Fix on next revision

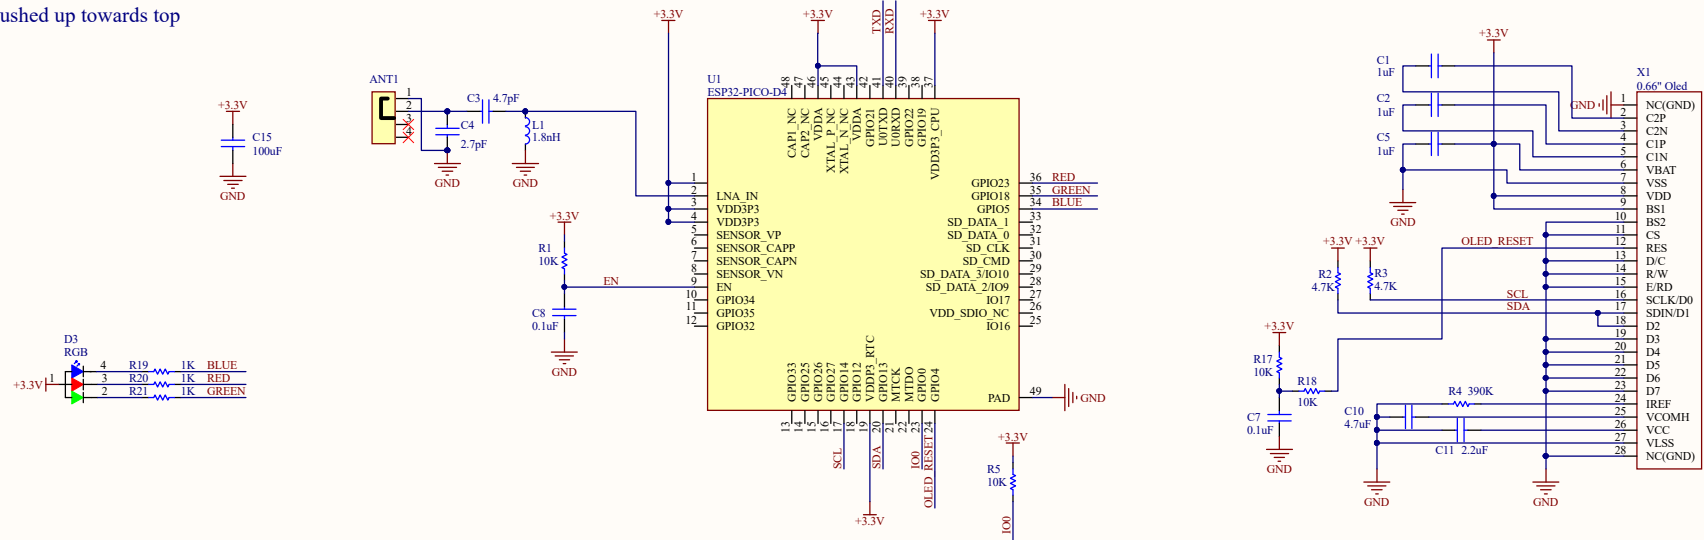
- RGB LED footpring wrong

- Oled display pads should be pushed up towards top
